AGENDA
PLANNING COMMISSION MEETING
Wednesday, January 6, 2021
7:00 P.M.
Maggie Osgood Library
70 N. Pioneer Street

- a. Land Use File 2019-04 – Sunset Hills Subdivision (Map 19-01-14-21, Tax Lot 05000)
 - Public Hearing
 - Commission Deliberation
 - Commission Decision
- b. Land Use File 2020-02 Property Line Adjustment – Map 19-01-14-24, Tax Lots 02200 and 02100
 - Public Hearing
 - Commission Deliberation
 - Commission Decision

TENTATIVE SUBDIVISION PLAN
SUNSET HILLS

SUNSET HILLS RESIDENTIAL SUBDIVISION

CUSTOM CATH BASIN INLET #1

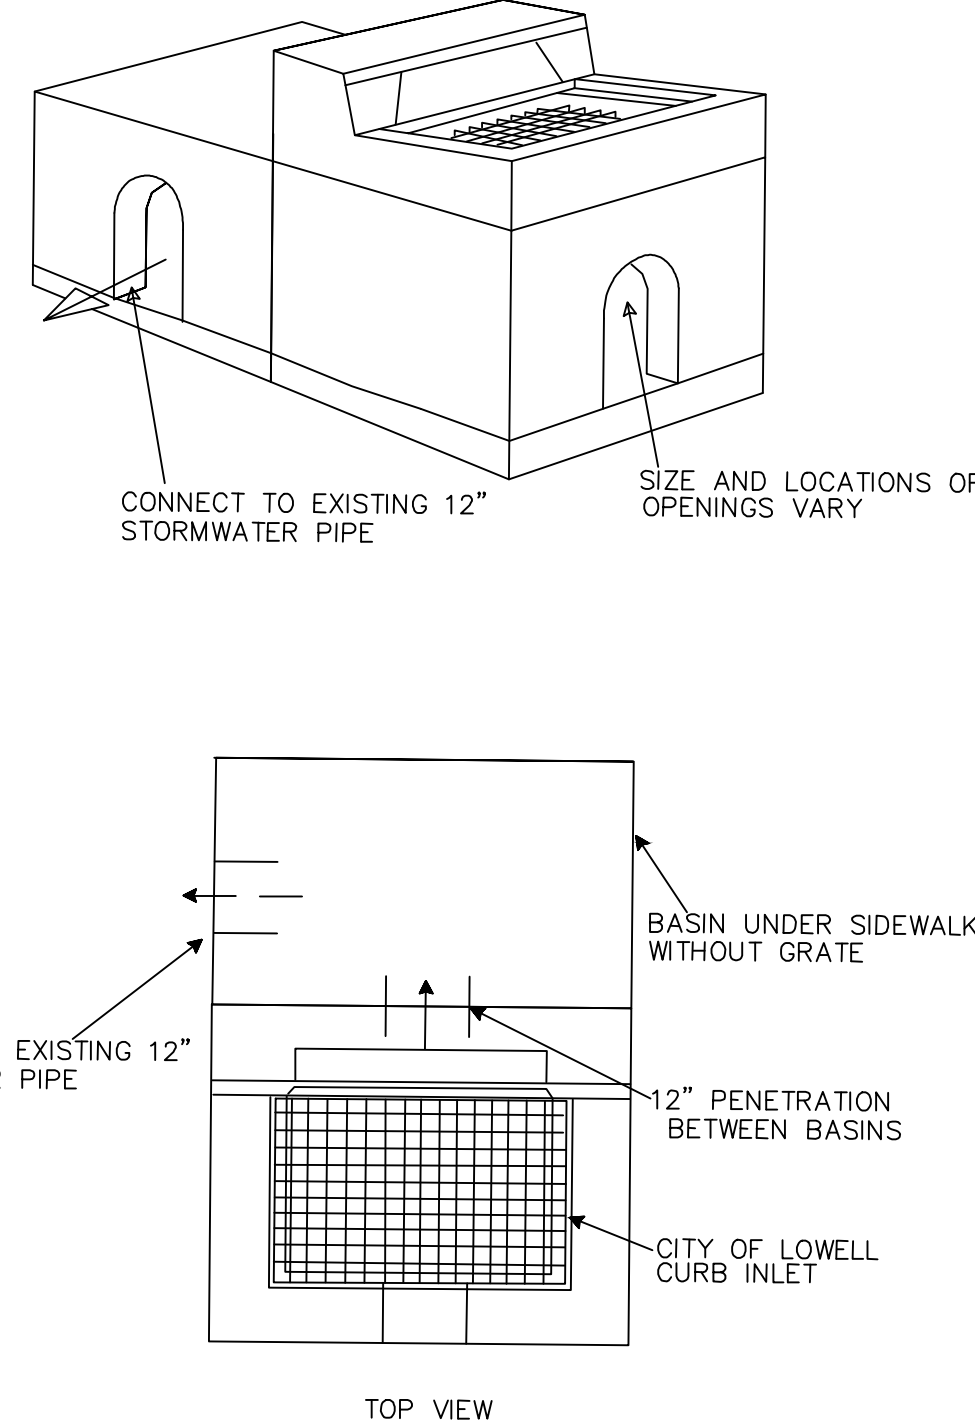
53. 4" cleanout detail should refer to SD 311 on sheet 8 for additional requirements.
54. 4" cleanout detail should show a temporary plug or cap in the lateral.
55. Custom Catch Basin Inlet #1 should have an access over the pipe. Access can be a vault style door, or a manhole. Blind connections are not allowed.
56. Sidewalk and Curb Drain detail. Provide calculations that show that a 12" x 3" tube will convey the peak stormwater beneath the sidewalk.
57. Sidewalk and Curb Drain detail. Provide reinforcement of concrete above the tube. At 2½" to 3" thick, the concrete will crack.

Sheet 3 of 12

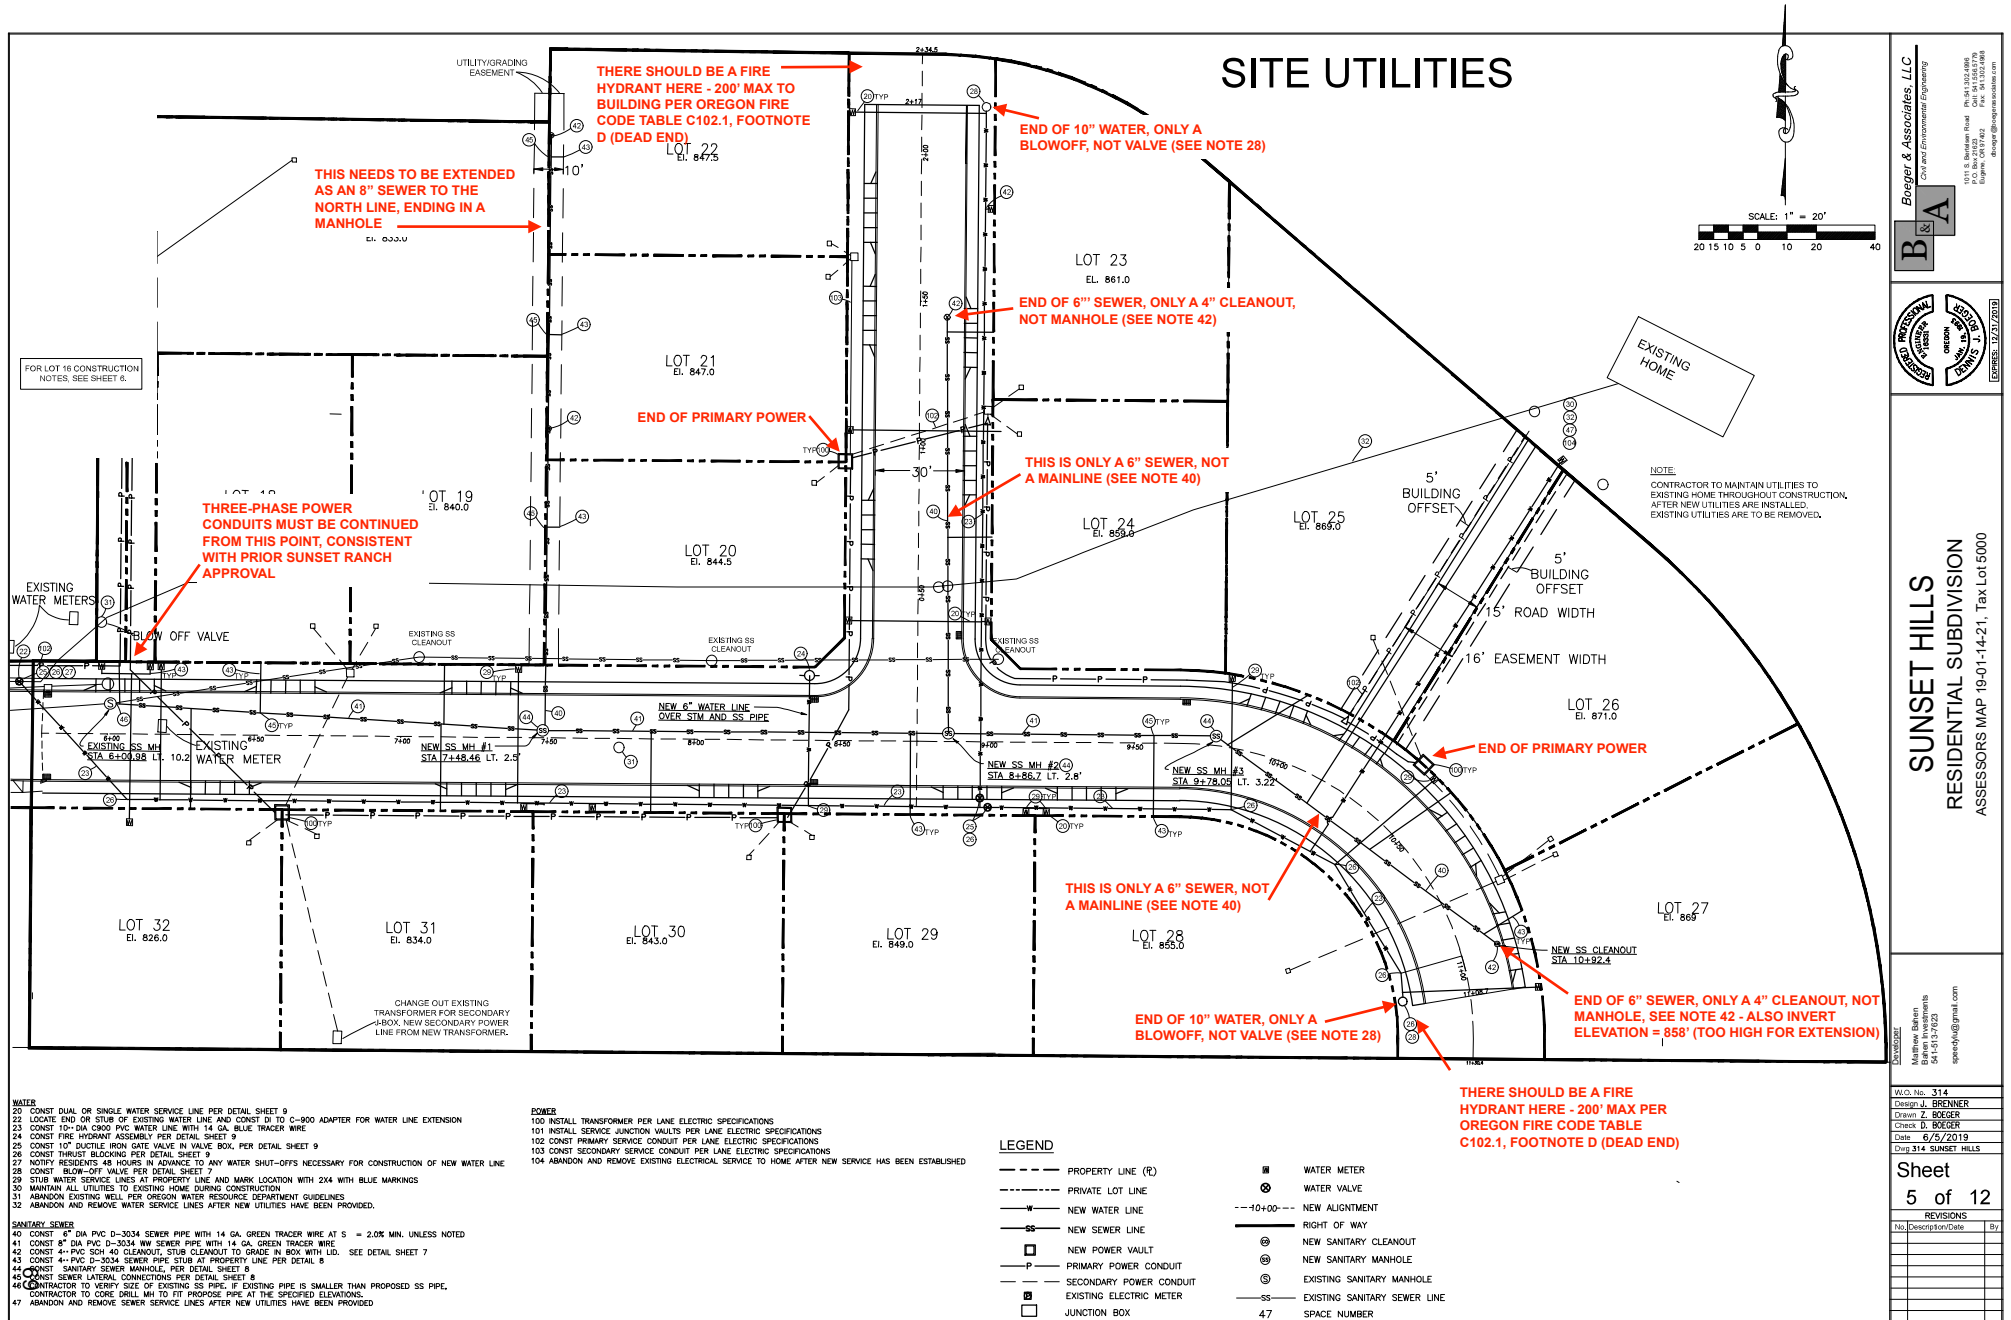
26. Calculations need to be included in the Drainage Report showing that the catch basins (Drop Inlet per Detail Sheet 7) will capture the entire runoff volume. Catch basins on a continuous grade need to be calculated differently than those in a sag.
27. Paving, Grading & Miscellaneous note #71; Driveways (at least the public portion and ramps) need to be 6" concrete.
28. Section B shown at the back of lot 27 does not refer to where the detail is shown. Add sheet number.
29. At the east end of the street, add inlet and outlet grades to the 18" CMP. Show that the road extension will be able to cross over the culvert with appropriate cover.
30. Note in bottom right corner of plan sheet has typo. "... around NE development..."
31. Show water and sewer pipes (lightly) and call out crossing separations between all utilities.

The staff report says “Prior to the issuance of building permits, the applicant shall submit specific construction plans to the City Administrator, or his or her designee, for review and approval.” But Sheet 3’s proposed grading plan IS a specific construction plan, with detailed finished grades down to the foot, and it clearly violates the city’s standards. We don’t know what a compliant plan would look like. It may require a redesign of key aspects of the development.

b) The sewer main is located under a steep fill bank and will be inaccessible for maintenance. As can be seen on Sheet 3 of the original plans (which have not been updated), this sewer line is proposed to be located under a 1:1 fill bank, with a drainage swale on top of that. This city will not be able to access and maintain this line, unless the sewer line is moved to the east, well away from the fill bank and drainage swale. The proposal violates SPI(III)(B)(4).
